5180-04-83

Reviewed By
LMK 04/19/2017

NO.	DATE	REVISION	BY
<div></div> <div>SHORT ELLIOTT HENDRICKSON INC.</div>			
STATE OF WISCONSIN DEPARTMENT OF TRANSPORTATION			
ACCEPTED _____		DATE _____	
CHIEF STRUCTURES DESIGN ENGINEER			
STRUCTURE B-12-37			
STH 60 OVER CLEAR CREEK			
COUNTY	CRAWFORD	TOWN/CITY/VILLAGE	MARIETTA
DESIGN SPEC. REHABILITATION N/A			
DESIGNED BY	DESIGN CK'D.	DRAWN BY	DLF
		PLANS CK'D.	CJB
CONCRETE OVERLAY			SHEET 1 OF 2

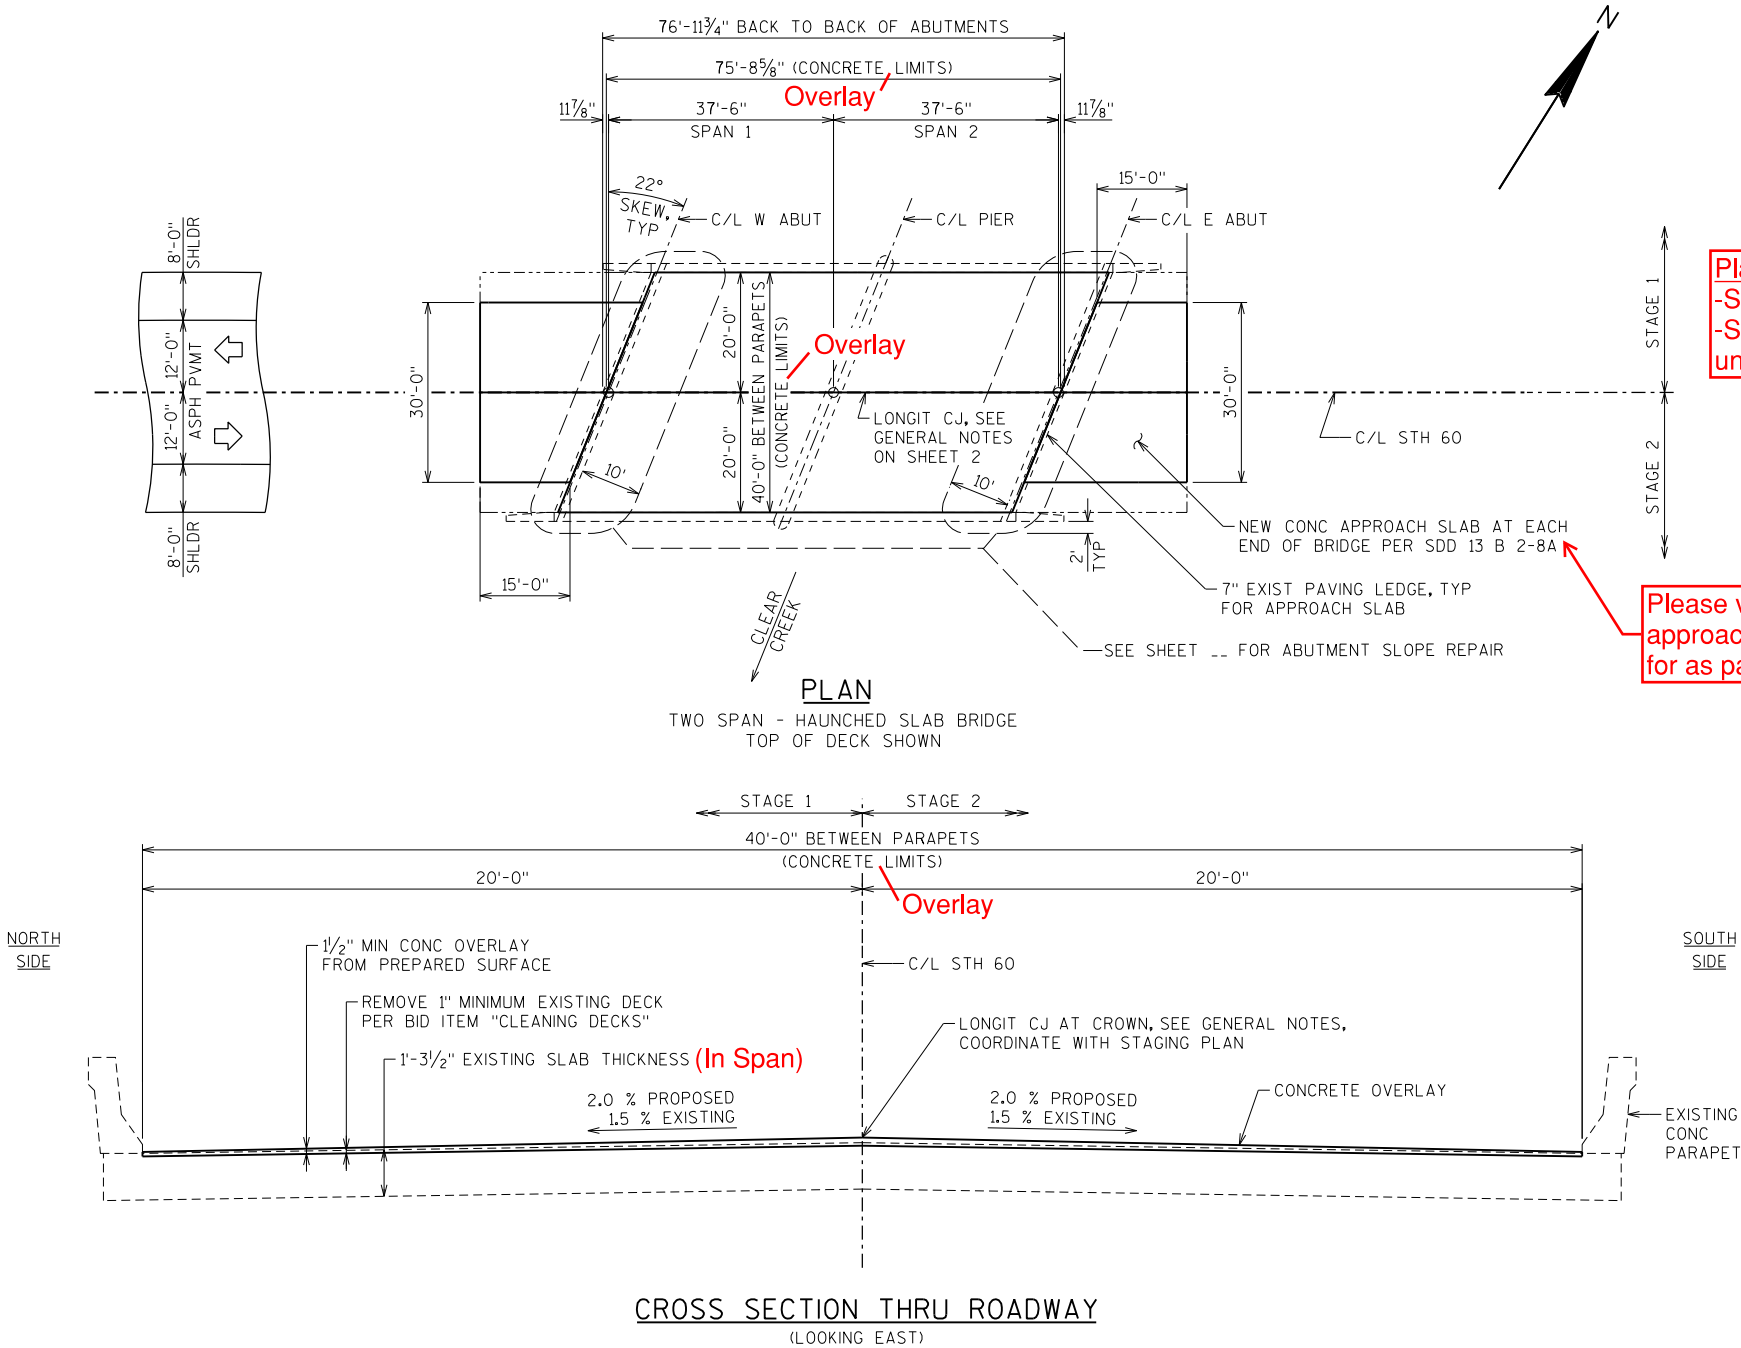
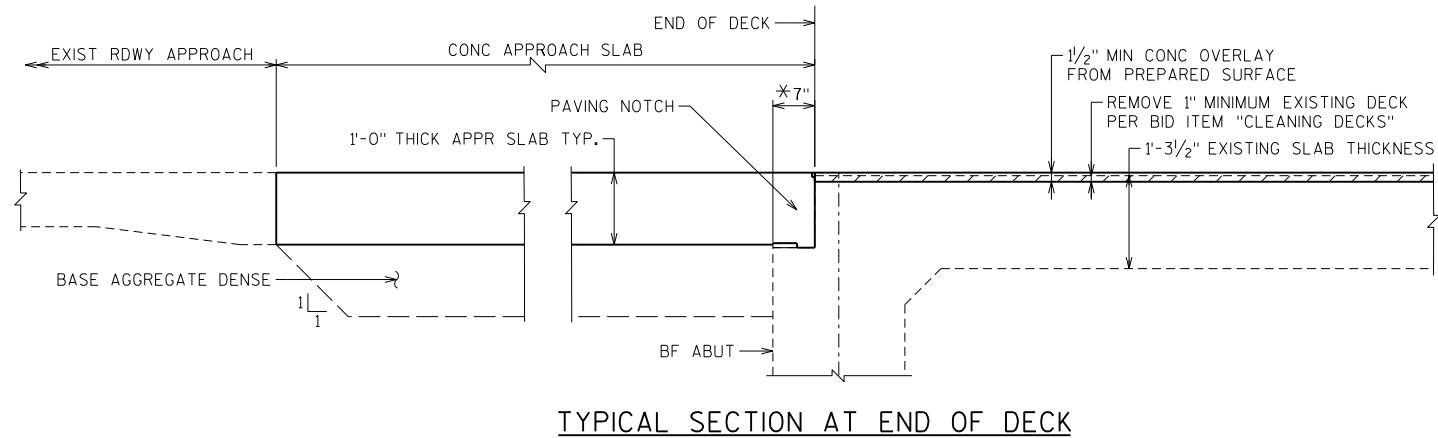
Plan view:
-Show alignment stationing
-Show stations @ substructure
units (CL brg abut, CL Pier)

Please verify. Non-structural
approach slabs are typically paid
for as part of the roadway plans.

General Comments
-Show how traffic will be handled on
bridge during construction
-Provide elevation view per BM 6.2.2.3.2

Fill in for prelim plans
whenever possible

Roadway plans were not
submitted. Could not verify
roadway-related items.
Please submit roadway
plans for future projects.

BASE AGGREGATE DENSE LIMITS

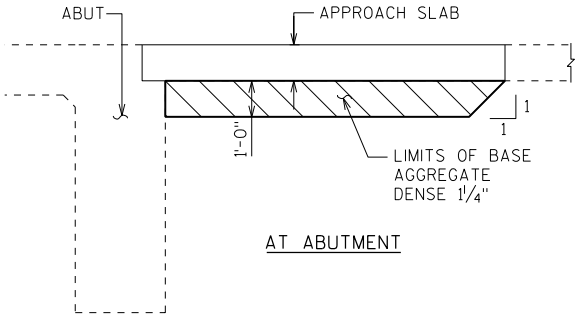
Typically roadway items
